PROJECT NO. I-4729A  
 POLK COUNTY  
 STATION: 22 + 87.20 -RP-E-

SHEET 4 OF 4

GENERAL DRAWING  
 BRIDGE OVER  
 RAMP (-E\_CONN\_REV-) ON  
 RAMP (-RP\_E-) BETWEEN  
 I-26 AND US 74

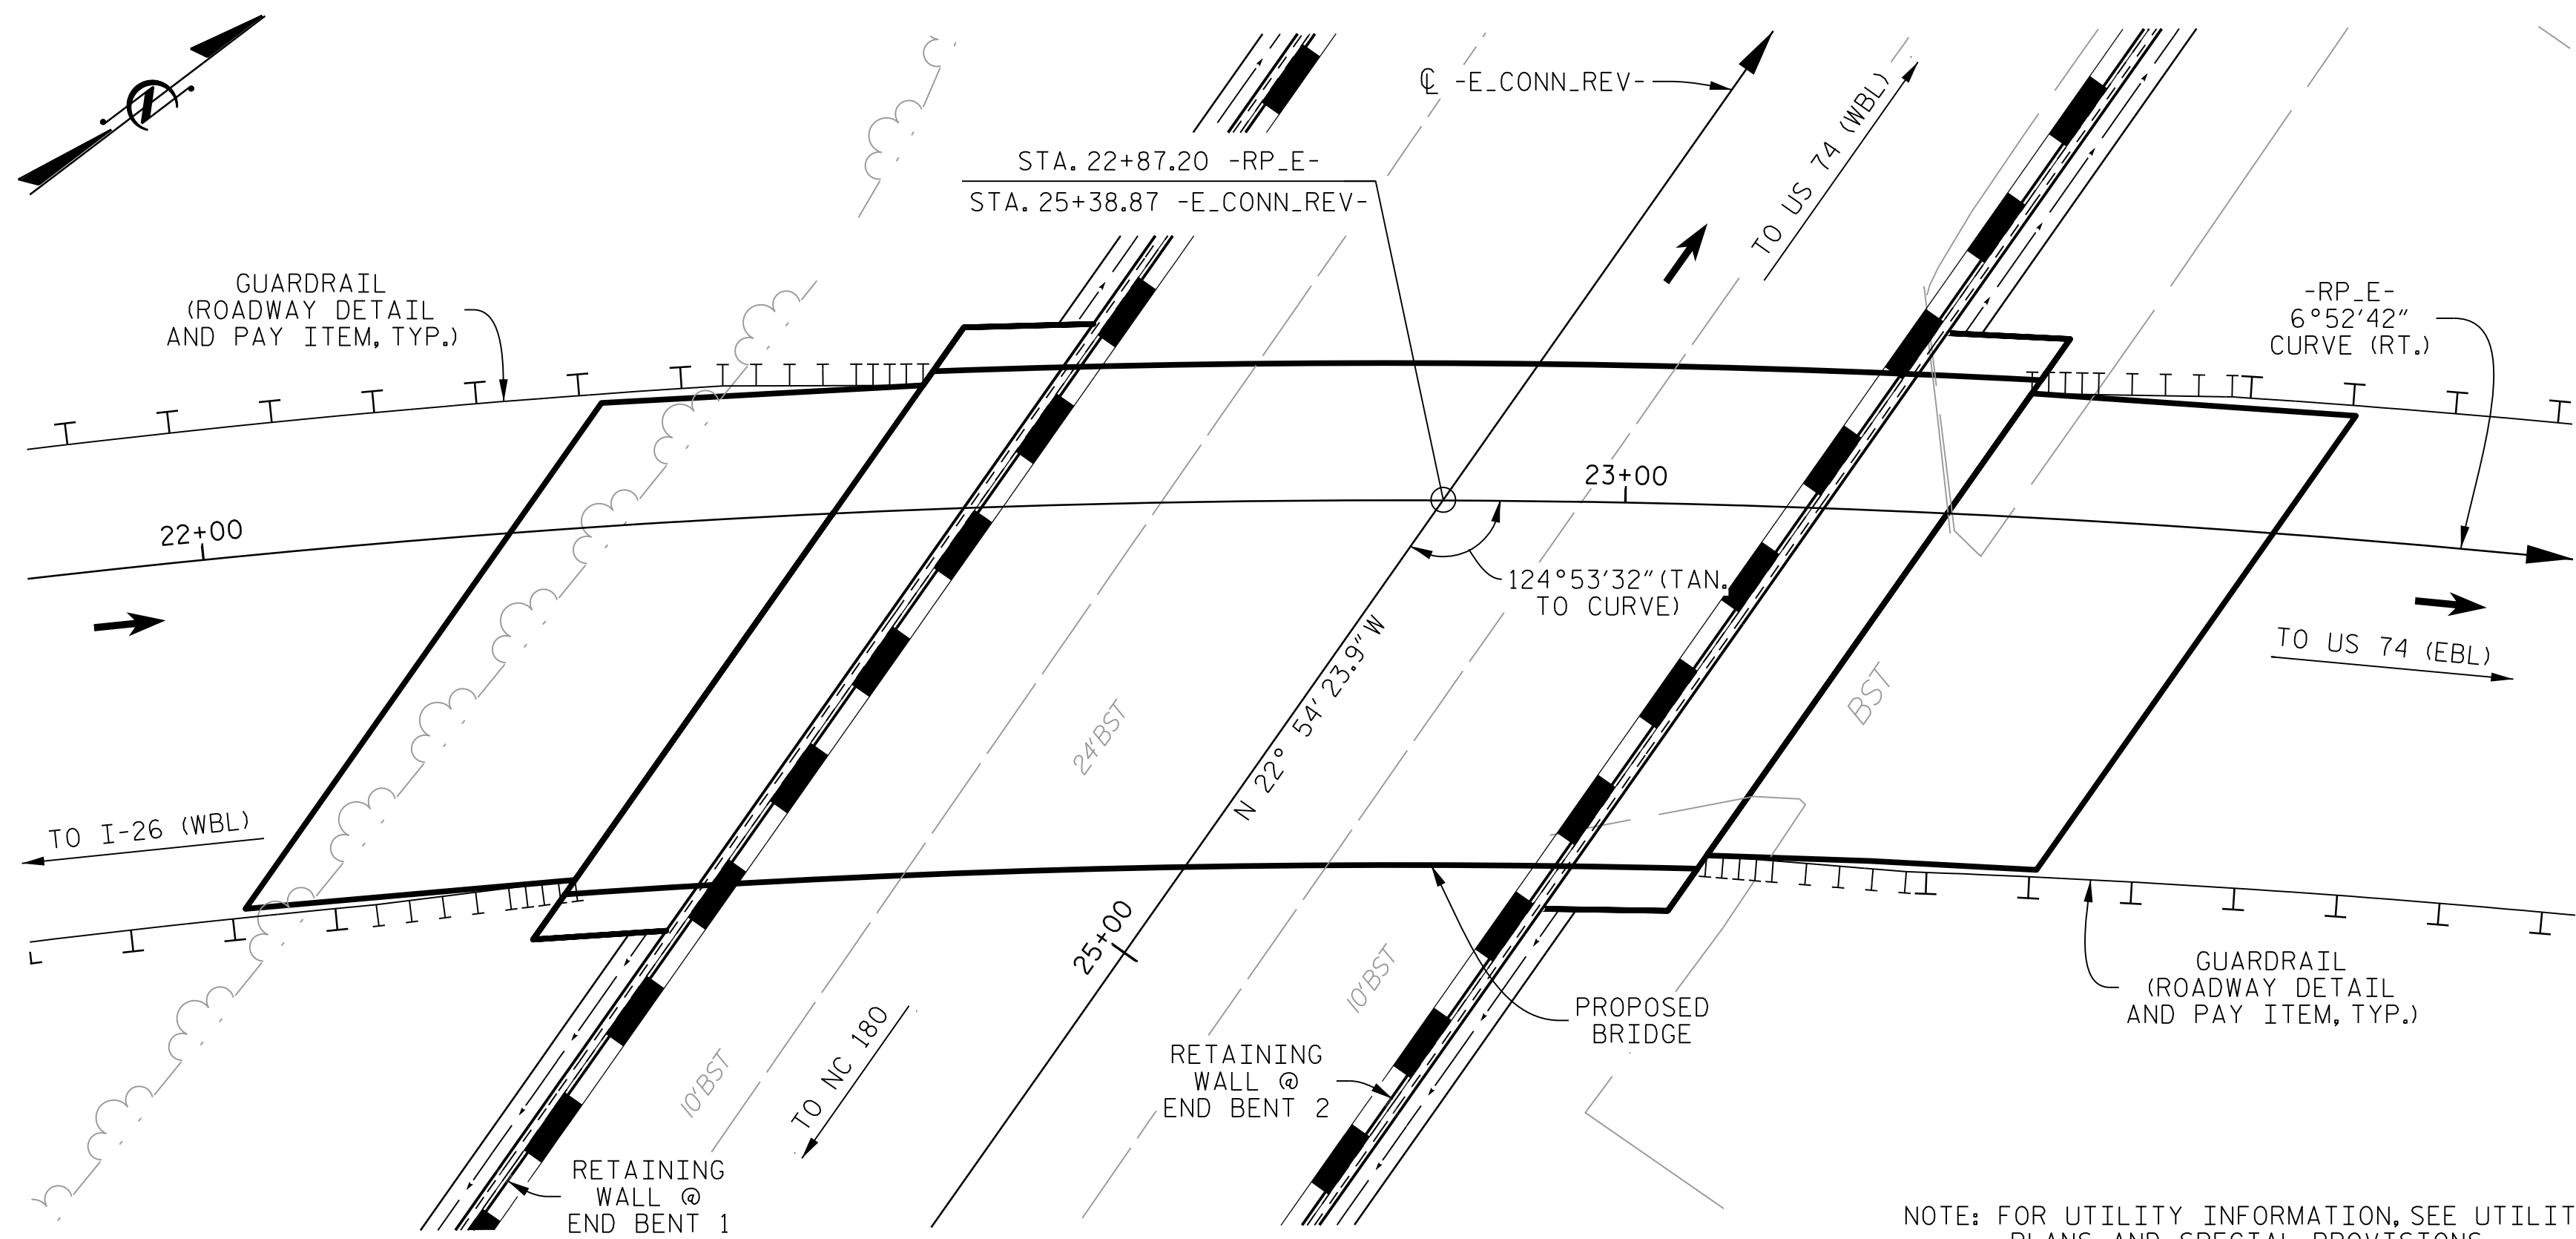
1 REVISED PILE SIZE AND NOTES.
